## **FINAL ORAL VALIDATION DOCUMENTATION**

**EE482 – K01**

Enhancing Energy Efficiency Through Modification of Electrical Plans:  
Addressing Power Instability and Improving Power Consumption in SAL,  
LRAC, and T-Room Buildings at Cebu Institute of Technology – University

**Figure 3** SAL, LINK, TROOM, CLINIC, and LRAC Buildings Assessments and Comparative Assessment

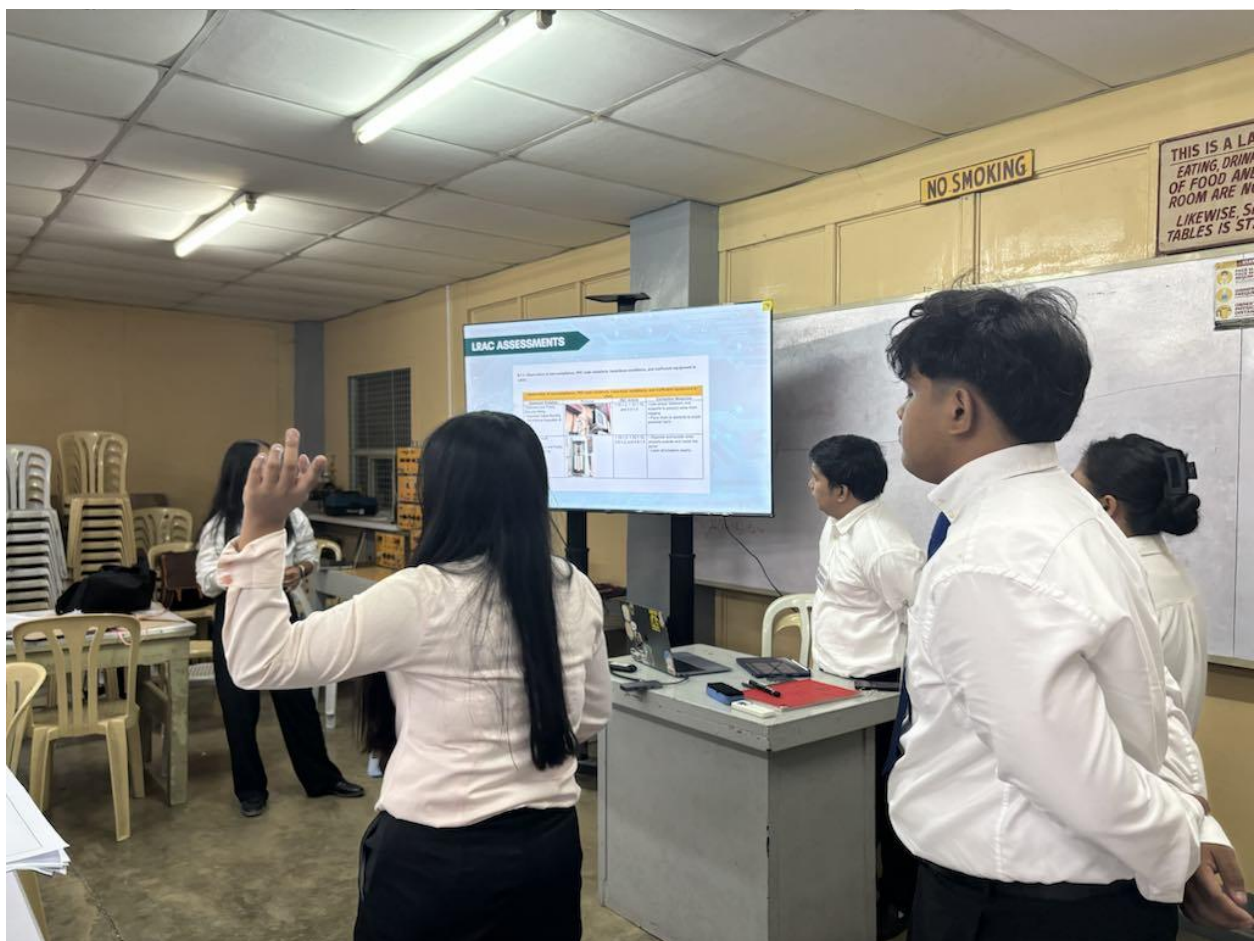
Atty. Engr. Julito B. Añora, Jr. also advised to include pictures showing how panelboards should look—providing before and after comparisons in the assessments.

**Figure 4** Summary of ETAP Inefficiencies and Total Calculated KVA Savings

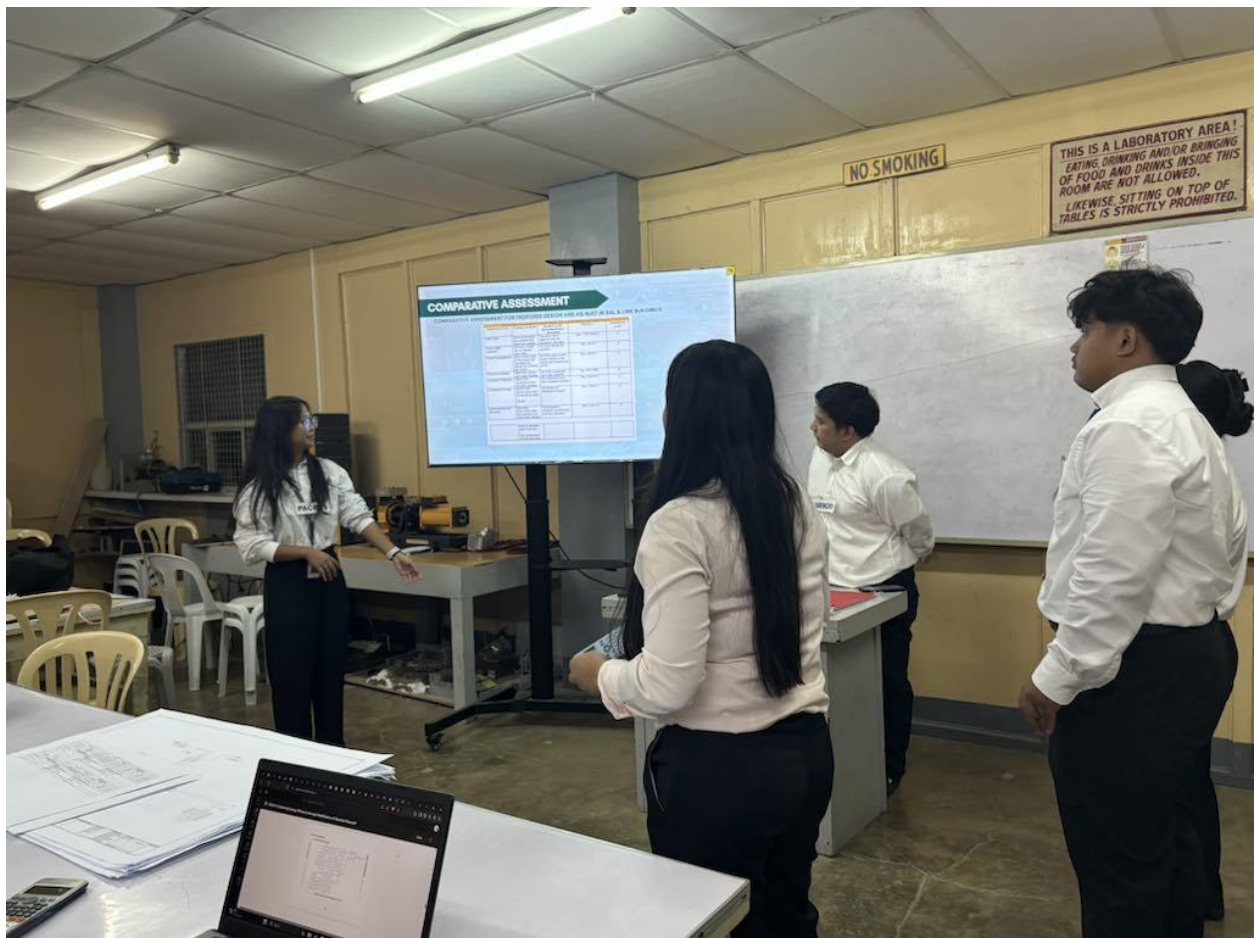
Advisor Atty. Engr. Julito B. Añora, Jr. emphasized visual documentation (e.g., before-after panel comparisons, simulation graphs) and clarified that “Acceptable” (minimal compliance, e.g., 2.45% savings), “Optimal” (balanced efficiency, e.g., 12.72% reduction), and “Excellent” (holistic success, e.g., 23.75% savings) are beneficial classifications under PEC 2017, guiding future prioritization and refinements.

**Figure 6** Questions and Answers from the Panelists

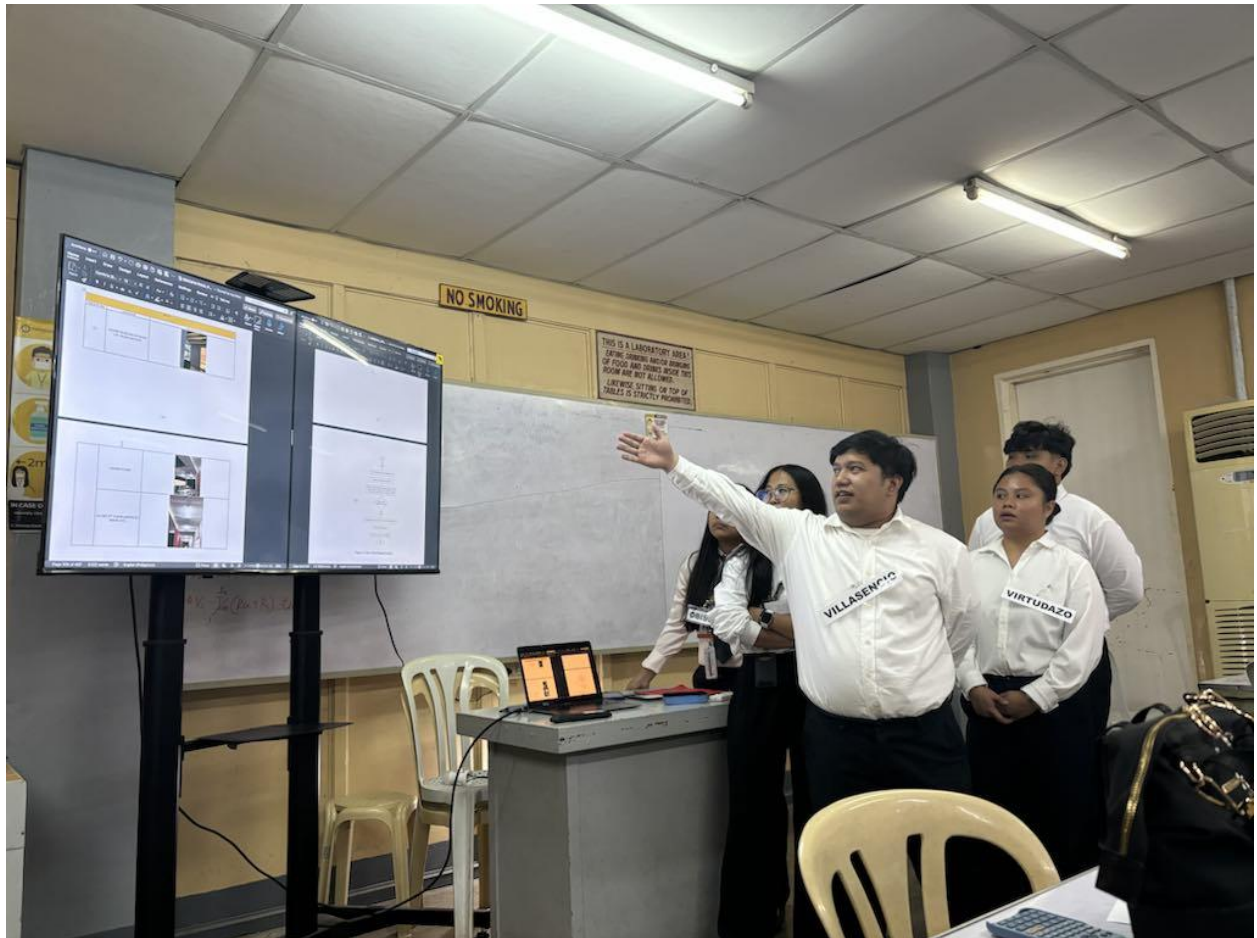
The panel addressed the 7.2% voltage drop reduction, achieved by upgrading PB-06 conductors and rebalancing loads via ETAP simulations to meet PEC 2017's  $\leq 5\%$  limit. Before-and-after visuals (e.g., rusted vs. upgraded panelboards, ETAP graphs) will be included per Advisor Añora's guidance. Tables like 3.10 (conductor sizing) and 4.1 (kVA savings) comply with PEC 2017, emphasizing 23.75% total savings. The SAL & Link's 12.72% "Optimal" rating reflects cost-efficiency balance, while "Excellent" denotes holistic success (23.75% system-wide savings). The advisor stressed cross-referencing visuals in appendices for clarity.
